# Access Compliance Report

## Public Rights-of-Way

Intersection ID: 30320	Main Street: EUROSTAR_DR	Cross Street: STOURBRIDGE_LION_DR	Location: S
ADA ID: 480BE17CF4F0	Ramp Type: PerpDiag	Initial Pass/Fail: Fail	Overall Compliance: No
		Severity Score: 35

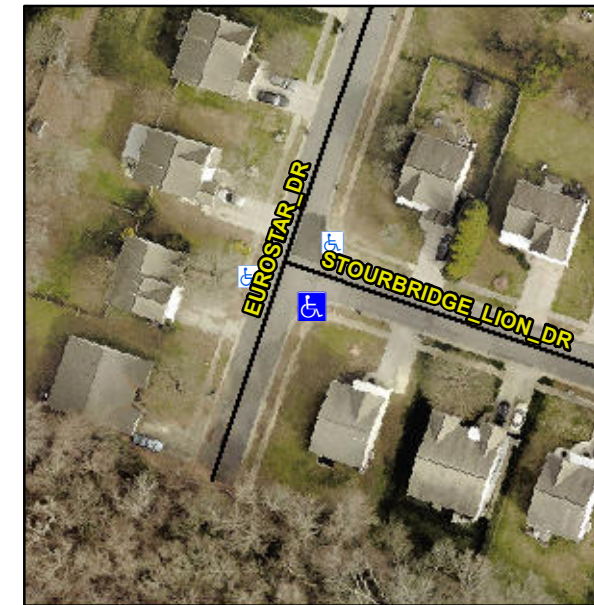
**Not Found, R304.5.1, R304.2.2, R304.5.3**

Compliance	Description	Data	Compliance	Description	Data
N/A	Ramp Length (in)	48.0	No	Ramp Slope (%)	14.3
No	Ramp Width (in)	44.0	No	Ramp XSlope (%)	4.4
N/A	Flare Type LT	N/A	N/A	Flare Type RT	N/A
N/A	Flare Slope LT (%)	N/A	N/A	Flare Slope RT (%)	N/A
N/A	Flare Traversable LT?	N/A	N/A	Flare Traversable RT?	N/A
N/A	Landing Length (in)	N/A	N/A	DWS Provided?	N/A
N/A	Landing Width (in)	N/A	N/A	DWS Contrast?	N/A
N/A	Landing Slope (%)	N/A	N/A	DWS Length (in)	N/A
N/A	Landing X Slope (%)	N/A	N/A	DWS Full Width?	N/A
N/A	Landing Curb? (Y/N)	N/A	N/A	DWS Offset (in)	N/A
N/A	Shared Landing?	N/A			
N/A	Gutter Ponding?	N/A	N/A	Gutter Slope (%)	N/A
N/A	Gutter Lip Ht (in)	N/A	N/A	Gutter X Slope (%)	N/A
N/A	Painted X Walk1?	No	N/A	Painted X Walk2?	No
	X Walk 1 Direction	To E		X Walk 2 Direction	To W
N/A	X Walk 1 Width (in)	N/A	N/A	X Walk 2 Width (in)	N/A
	X Walk 1 Slope (%)	0.4		X Walk 2 Slope (%)	0.0
	X Walk 1 X Slope (%)	5.4		X Walk 2 X Slope (%)	0.7

**Remove & Replace Curb Ramp With Two New Directional Ramps or Equivalent.**
